**FINAL DRAINAGE REPORT FOR
HOMESTEAD AT STERLING RANCH
FILING NO. 2**

Engineering Review

Project #09-007
SF -19-004

Figure SF-1. Sand Filter Plan and Sections

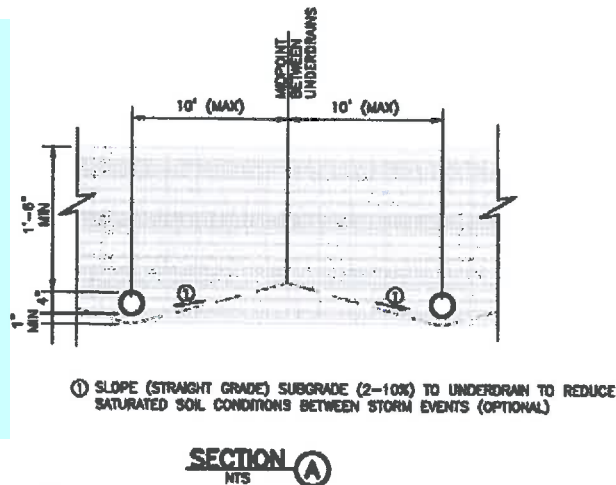
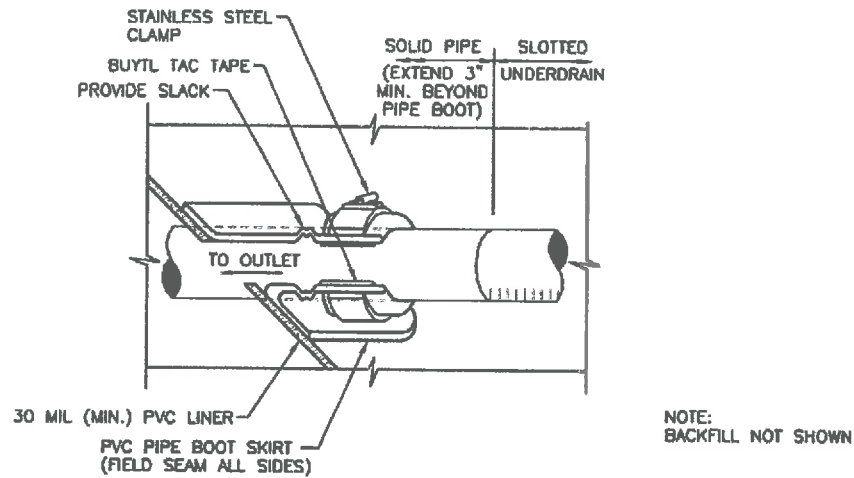
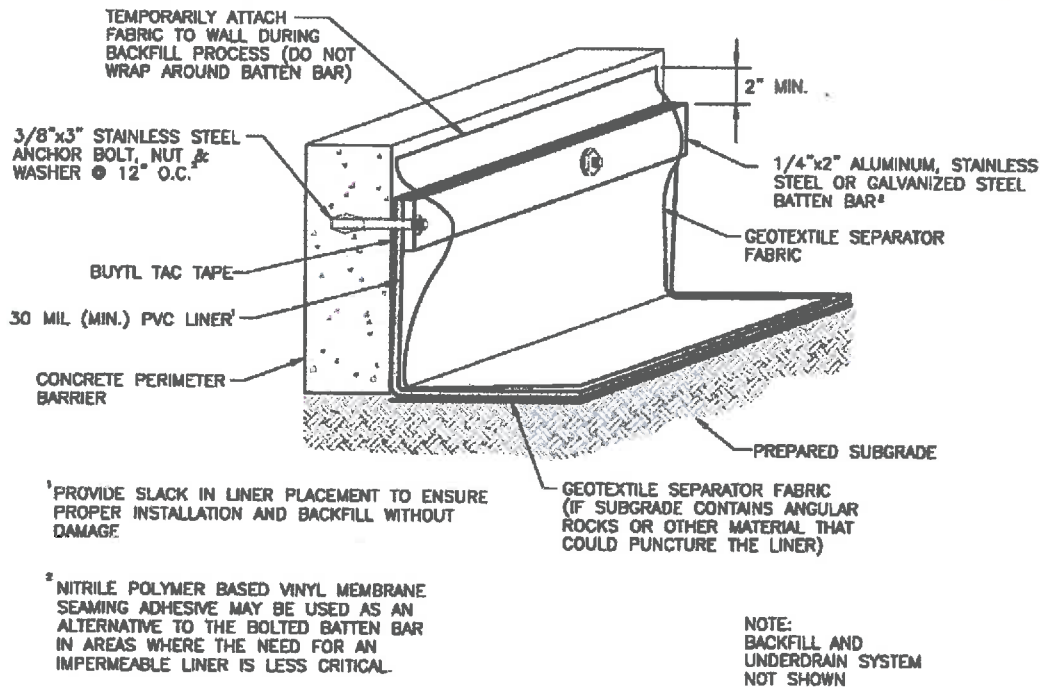
Add a more specific detail for the 52 SFB's that will be used for backyard WOCV. Since all 52 will be similar, provide the outlet structure detail, the outfall pipe sizing information, Fencing, (Split rail fence), etc.

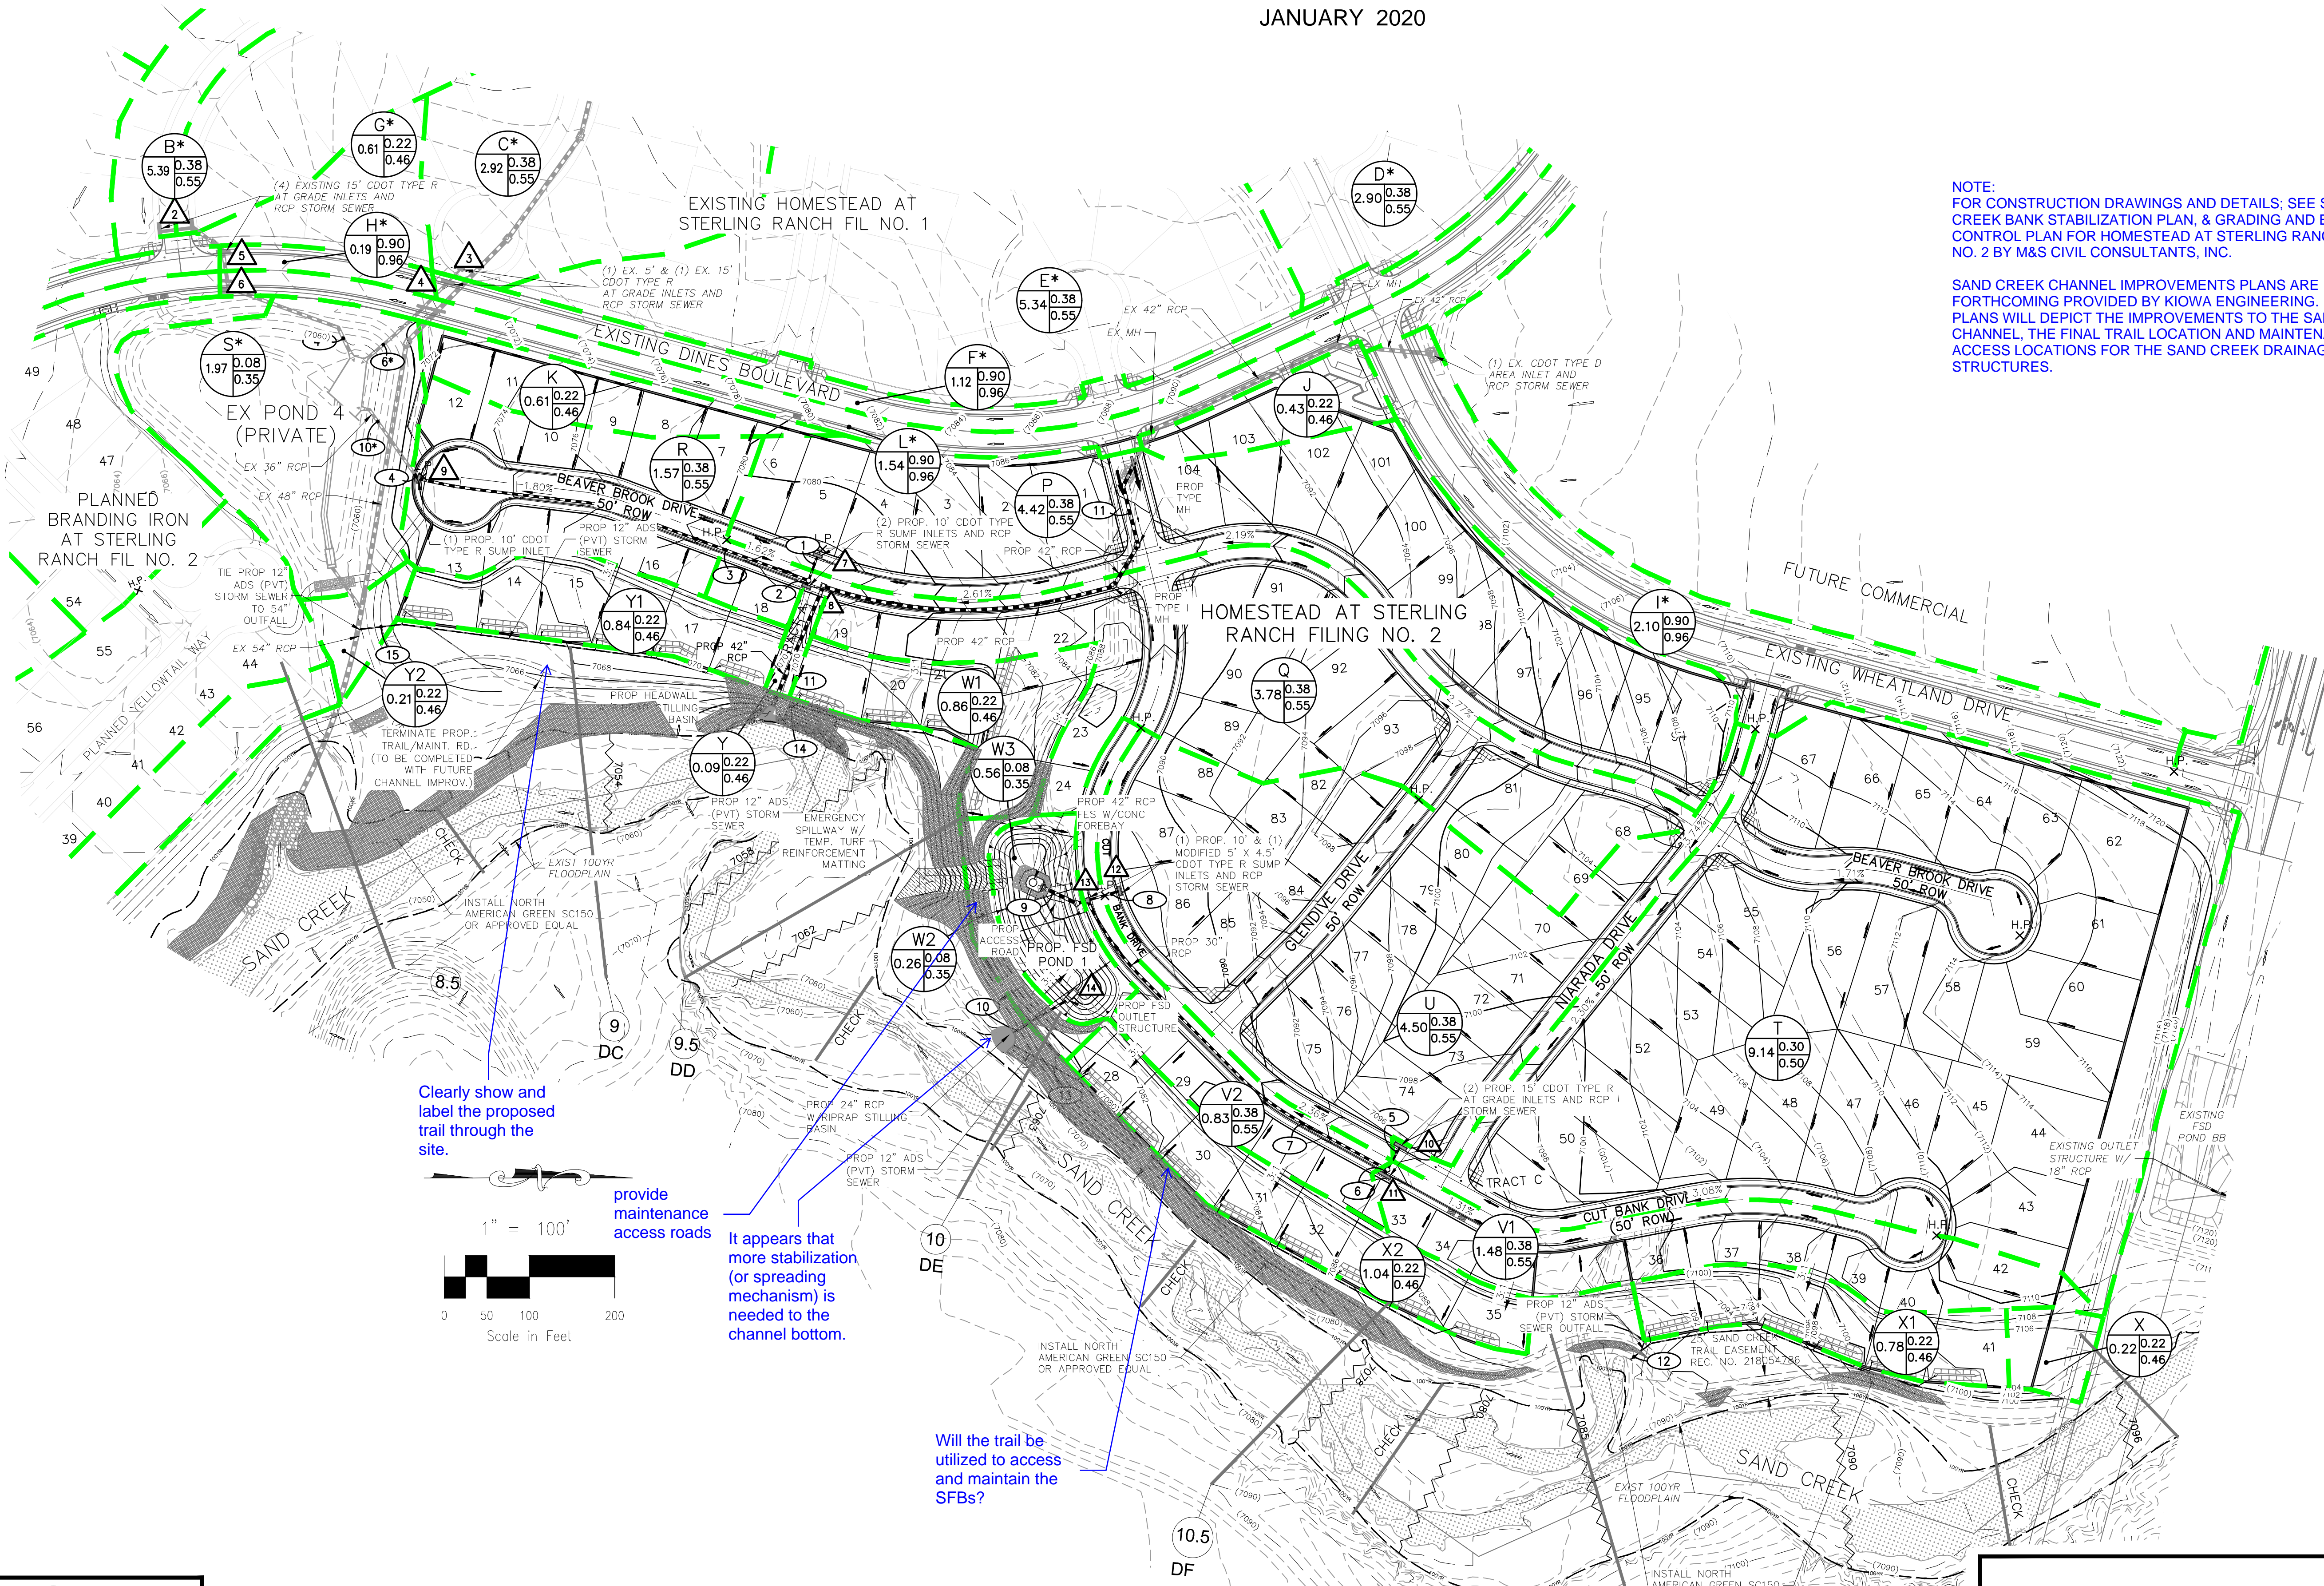
Clearly show and label the proposed trail through the site.

provide maintenance access roads
